Submittal #233600-04.2 - AIR TERMINAL UNITS - Product Data 233600 - AIR TERMINAL UNITS

Grain Valley Police

Specification Section: 233600-2.2
Manufacturer: Price Industries
Equipment: Fan Powered Boxes

All-In-One Terminals

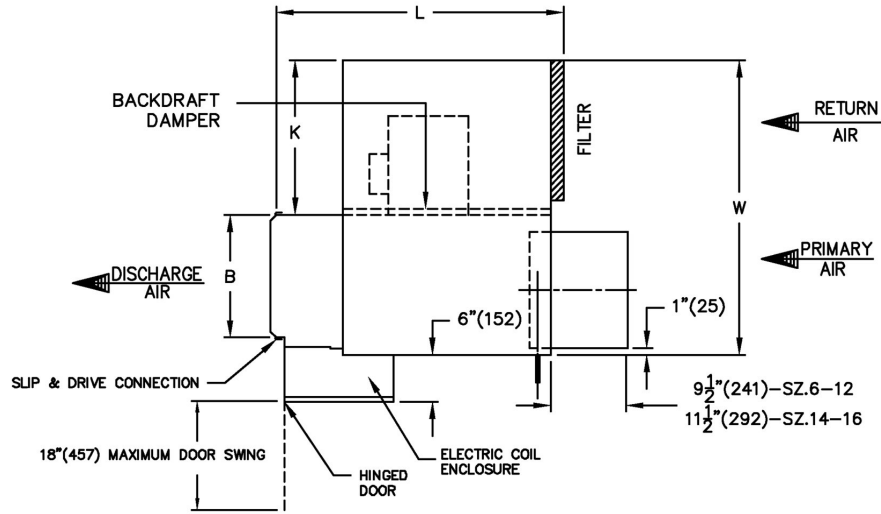
To achieve the desired 11kw electric coil,
the fan flow CFM needed to be bumped up 600 CFM.

Is that acceptable?

revise to 400
 with increase in
 fan flow.

STILL MISSING RESUBMITTAL FOR SINGLE DUCT VAV BOXES.
